Amendments to the Drawings:

REMARKS/ARGUMENTS

Objection to Figure 6

Annotated Sheet Showing Changes to Fig. 6

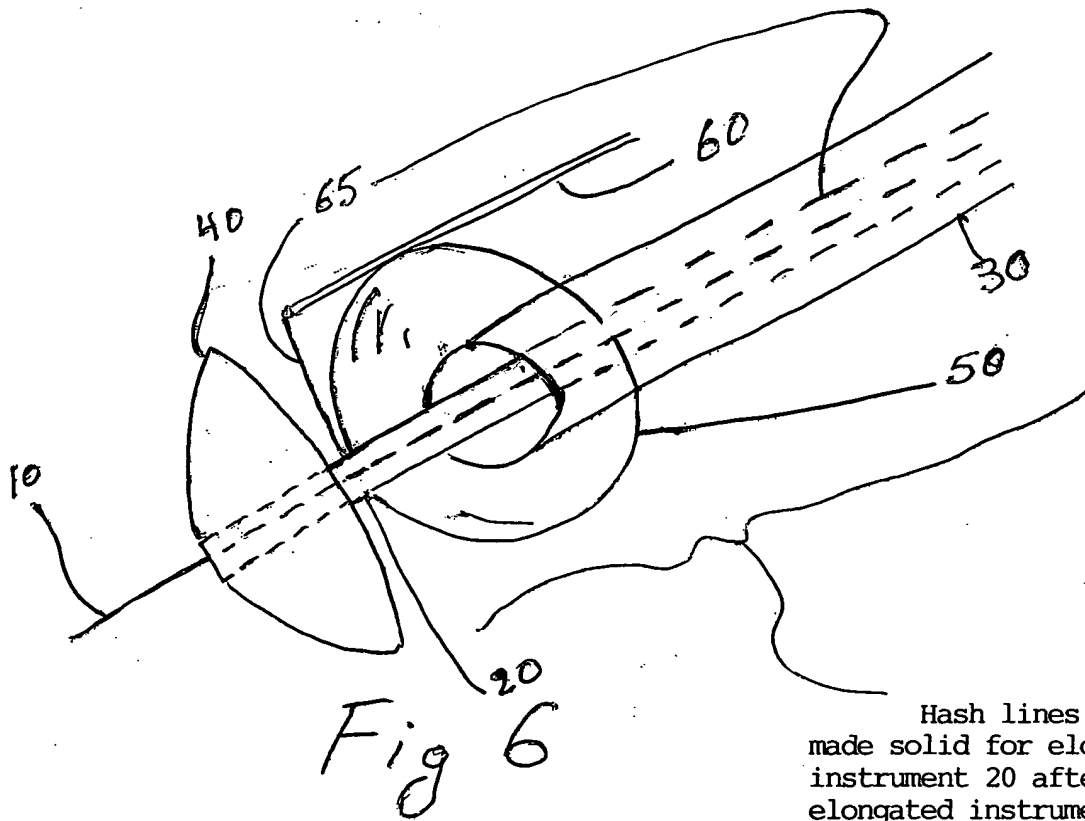
At page 2 of the Office Action, the Examiner objects to Figure 6 and asserts that the collapsible plate (40) appears to be located on the guide, rather than on either of the elongated instruments as disclosed. This objection is respectfully traversed.

Hash lines have been made solid for elongated instrument 20 after exiting elongated instrument 30 and hash lines corresponding to elongated instrument 20 and guide 10 have been corrected

The attached drawing sheet replaces Fig. 6. The replacement sheet of Figure 6 shows that the collapsible plate is located on elongated instrument 20. To make this clear, the hash lines have been re-drawn, and elongated instrument 20 has been drawn to show that it is extending beyond the elongated instrument 30.

New Figure 6 was intended to show that the collapsible plate is located on elongated instrument 20. To make this more clearer, the hash lines have been re-drawn, and elongated instrument 20 has been drawn to show that it is extending beyond the elongated instrument 30. Accordingly, this objection should be withdrawn.
